## Hale Products, Inc. Service Bulletins

Bulletin#: SB79

Drive Line Interference on Manual Pump Shift Override

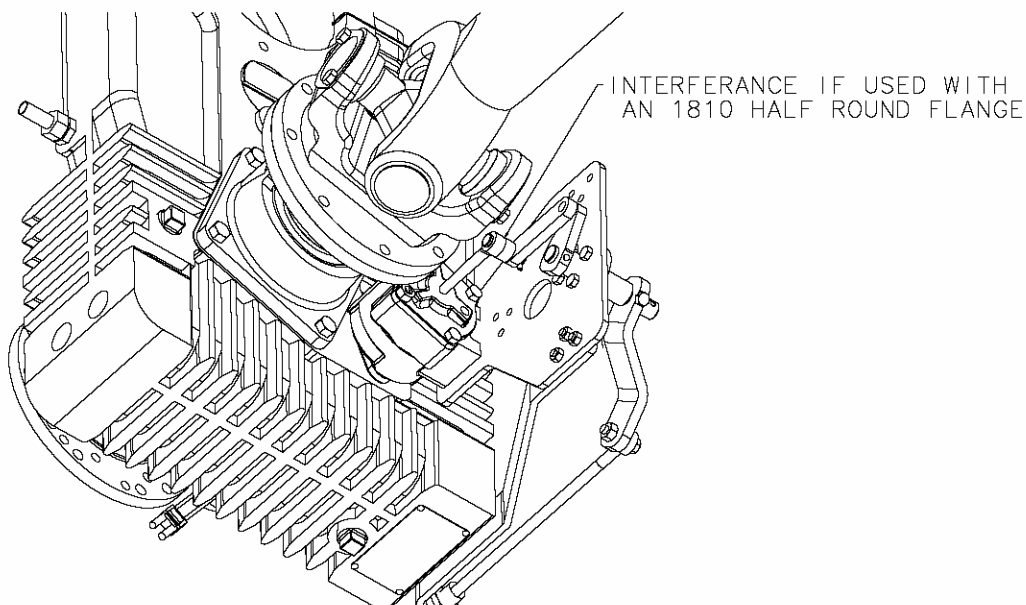
“Half Round” 1810 Flange style yokes interfere with the Manual Pump Override Shift Shaft on Hale G series gearboxes. Use full round when using 1810 flange style yoke

Drive shaft flange yokes in the half round style have a larger swing diameter than the full round flange yokes that are more popular in heavy and medium trucks. The half round flange style yokes will hit the linkage on the manual pump shift override kit when shifting into pump. Hale recommends using full round flange yokes with the manual pump override shift kit to prevent interference.

Another option is to order spline drive shaft connections in place of the standard universal drive flange on Hale midship pumps. Hale Products, Inc offers the option of spline shafts on all midship pumps. This allows the use of half round or full round yokes with the manual shift kit w/o interference problems. The midship order sheet shows the option for 2.75-10 spline drive shaft option on the gearbox. Note that some spline yokes are available from Hale Products, Inc. Note that this is an additional charge. It may be simpler and cost effective to utilize full round yokes with the manual pump override shift kit.
